Proposed relocation of Box Hill to Ringwood path to be on VicTrack land in Walkers Road, Nunawading.

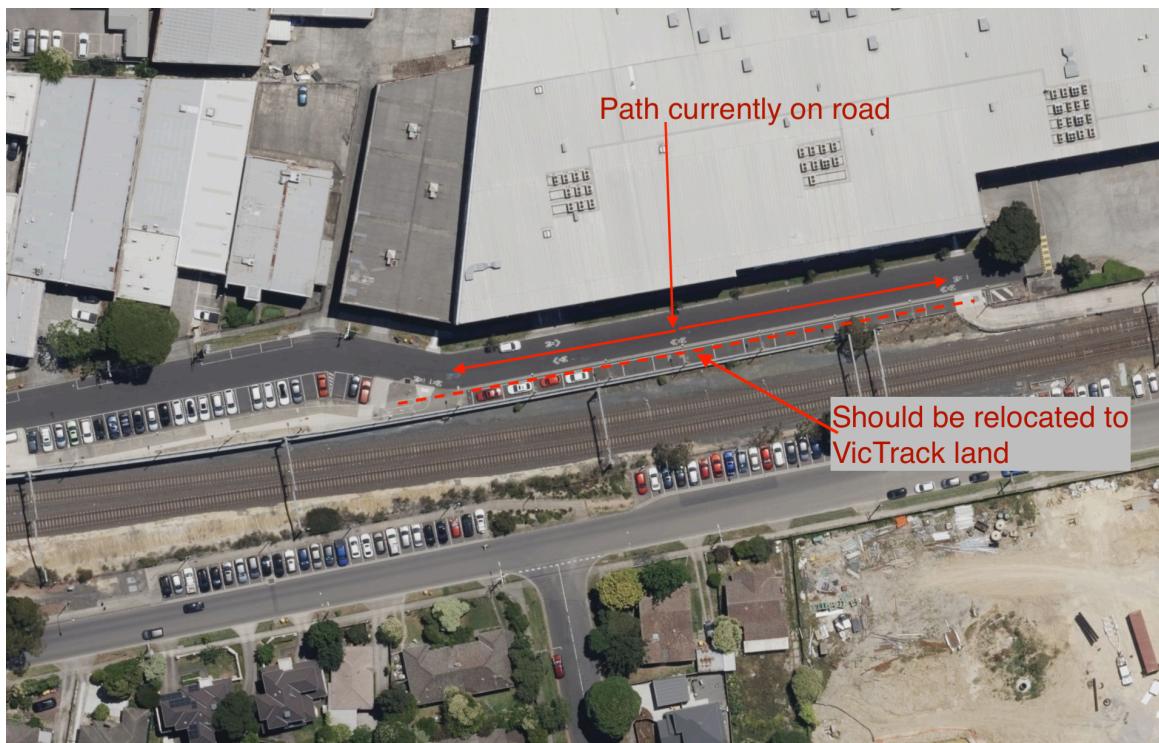
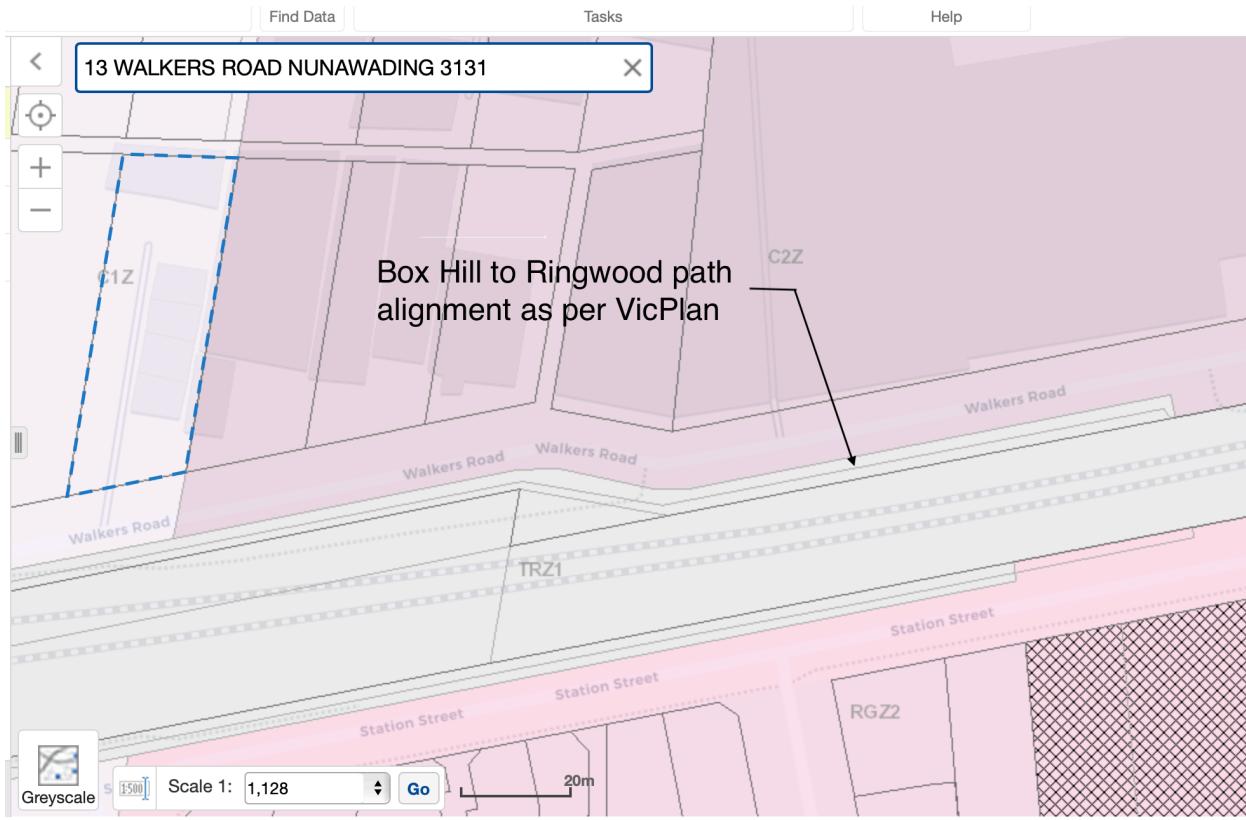
The Box Hill to Ringwood path is predominantly off road (separated) which is by far the safest and preferred option for cycling paths. However, there is a section of VicTrack land about 100 metres in length, on the South side of Walkers Road where the shared path should have been constructed. Instead, sixteen carparks have been created, forcing cyclists to share the road with vehicles, often vans or trucks accessing commercial premises in the area. Eastbound cyclists need to cross to the North side of the road and then after 100 metres, cross back to enter the separated path. Likewise pedestrians have to cross the road and cross back again. This is inconvenient and potentially hazardous. Moreover it demonstrates a mindset of devaluing active transport and walking, in favour of car use and the resulting traffic congestion.

It is proposed that these carparks be relocated to the North side of Walkers Road and thus free up the VicTrack land for the shared path as originally planned by VicRoads in 2016 and shown in its [Alignment Report \(March 2016\)](#). It is not clear why this alignment was not followed when the path was constructed. This original alignment also appears to be shown on the VicPlan map of the area.

Use of the space is predominantly unmetered commuter car parking. It could be accommodated through indented bays between the trees on the North side of Walkers Road.

MeBUG requests Council and VicTrack to jointly implement the suggested changed parking arrangement.
